## Planning and Land Use Committee Report

**Date:** March 20, 2014      **From:** Mike Wilson, Senior Planner – Urban Design  
**Subject:** **Development Permit Application #000297 for 1823 Douglas Street**  
The application is to construct a one-storey plus mezzanine commercial building for restaurant use with surface parking stalls.

## REVIEW OF DOWNTOWN CORE AREA PLAN OBJECTIVES AND GUIDELINES VIS A VIS PROPOSED DEVELOPMENT OF 1823 DOUGLAS STREET

1 SITE PLAN  
Scale: 1:100

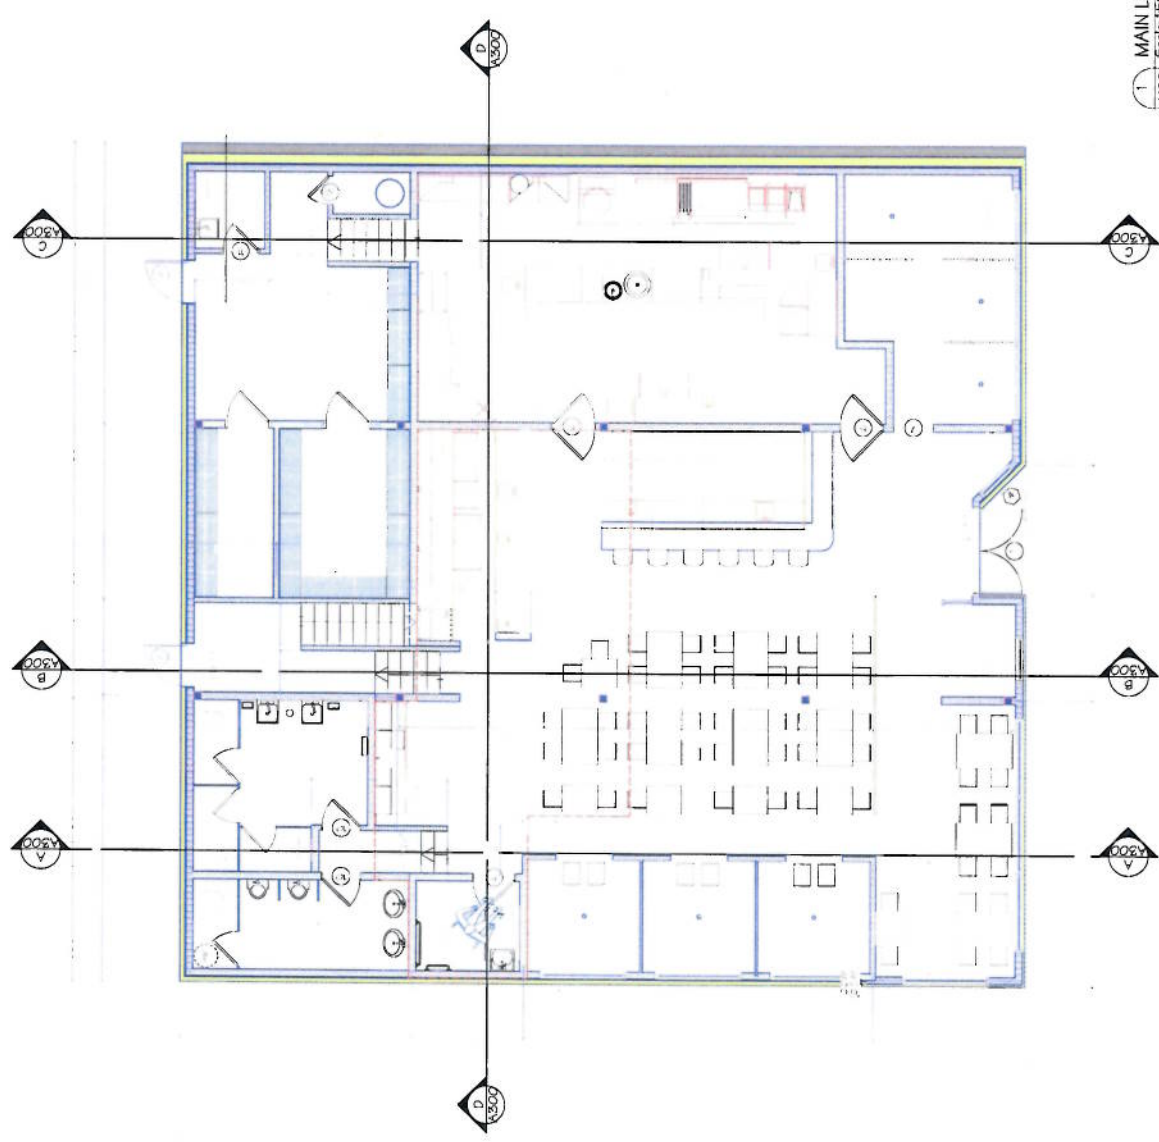
Section 3.19 of the Plan requires that parking for a new development be provided underground. The proposed seven surface parking stalls are neither consistent with this guideline nor has the applicant employed any design mitigation measures such as screening and landscaping that attempt to address this. Staff recommend that if the policy is to be maintained at grade that it be screened and landscaped more attractively and effectively.

The proposal includes a gated bicycle enclosure constructed of heavily galvanized-wire mesh and a 1.8 m tall wooden fence at the east and south property lines. The applicant has not provided detailed elevations of the fence materials or the bicycle enclosure. As a result, it is difficult for staff to comment on the proposal. Should this application move forward, staff recommend that the applicant submit detailed elevation drawings of all fences and gates on the site in order to ensure the proposal is compliant with the Guidelines.

We have also incorporated a number of changes on the site plan that were recommended by Parks Division and by Engineering and Public Works. These are bubbled on the plans. We have provided two street trees in tree grates and we have widened the Caledonia sidewalk so that the back of sidewalk is on the property line. We have revised the driveway crossing to meet Schedule B of the Highway Traffic Access Bylaw for a Type B crossing. We have slightly offset the driveway crossing with the drive aisle of the parking area to avoid the driveway flare coming within 1.5m of a Hydro Pole. The current crossing is in the same location as the proposed new crossing however the existing crossing did not conform to the Type B Crossing.

- 6.6 Consider the design and placement of streetscape improvements such as paving materials, street lighting, street furniture and landscaping in order to help enhance and frame view corridors. **(SEE NOTE ON EXISTING STREETSCAPING). WE HAVE ADDED TWO STREET TREES IN TREE GRATES TO THE CALEDONIA SIDEWALK.**

STREET WALL REQUIREMENTS

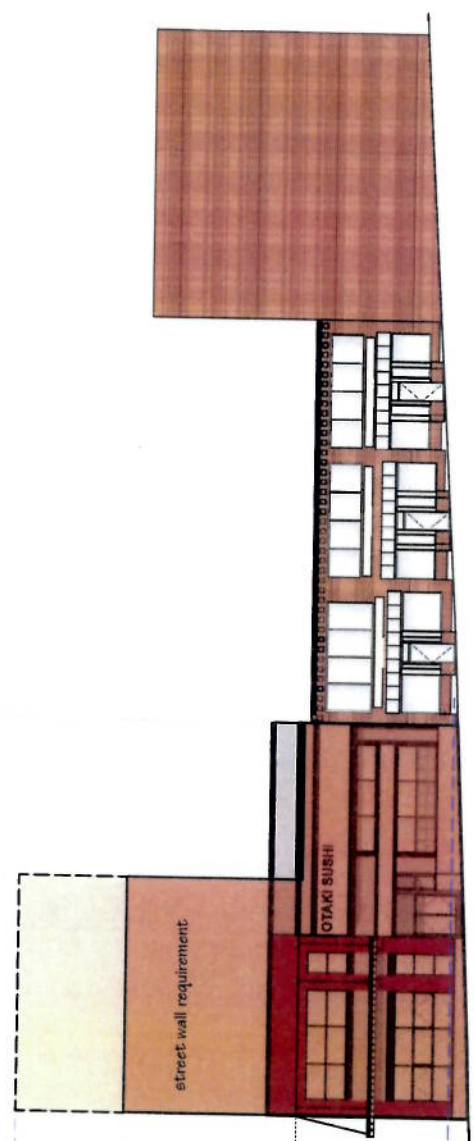
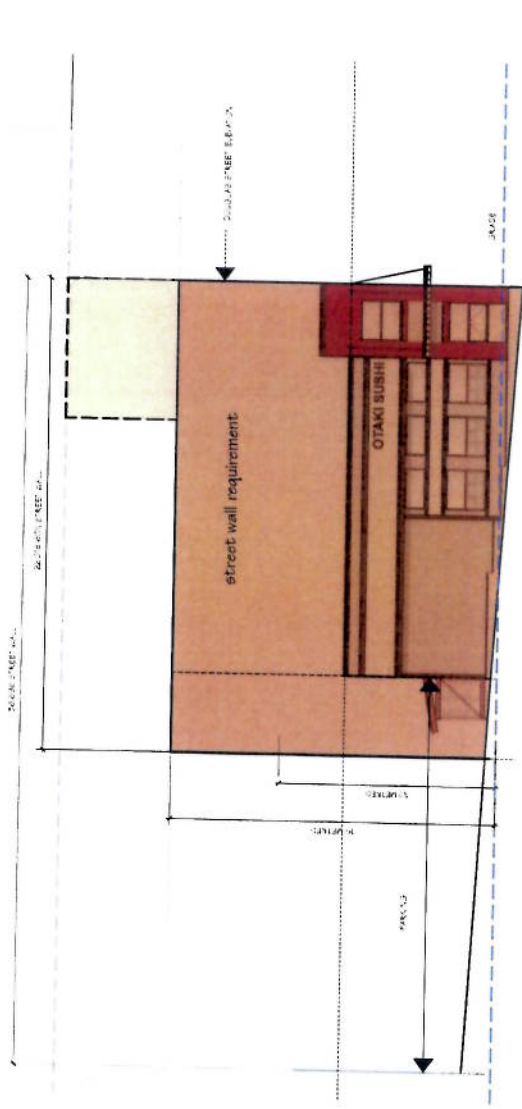
Section 6.187.1 requires that new buildings provide a primary street wall along a minimum length of 60% of the building face parallel to Douglas Street and that the street wall has a minimum height of 15 m and a maximum height of 20 m. The proposed primary street wall is comprised of 100% of the building face parallel to Douglas Street; however, at 8.4 m in height, it does not meet the minimum street wall height as required by the guidelines.

Caledonia Avenue is considered a "narrow street" and requires a primary street wall along a minimum length of 60% of the building face parallel to the street that has a minimum height of 10 m and a maximum height of 15 m. The proposed primary street wall only achieves 47% of the building face parallel to the street. Additionally, the proposed building height does not meet the minimum street wall height as required by the guidelines as the proposal is only 8.4 m in height.

Although the applicant suggests that the property is too small to construct viable street wall conditions that meet the guidelines, there would seem to be some solutions that could have been explored to provide more presence and better respond to the guidelines. If this application moves forward, staff recommend review by the ADP regarding to what extent this application may be able to respond more appropriately to other aspects of the guidelines such as the provision of high quality building finishes.

Please see the attached sketches indicating the implications of the Street Wall guidelines for this particular site.

While the internal height of the building will be 19' to the underside of the roof joists from the dining/kitchen area, the parapets on Douglas Street are set at 29' above finished floor to conceal the slope of the roof, the roof top mechanical equipment and to add aesthetic weight to the Douglas street elevations and the corner. The parapets facing the rear and facing Caledonia are 25' high above the dining room floor.

The Street Wall Drawings we have prepared illustrate that the Core Area Design guidelines for the height of the Street Wall are about double the requirements for the building proposed on the site. To achieve the building heights required by the guidelines we would need a 4 storey building which as discussed above is not feasible for this site with respect to efficient design and economics.

We have prepared two street wall drawings – one illustrating the December 2012 scheme and a second showing the modest changes we have made to increase the height of the building and the massing at the corner.
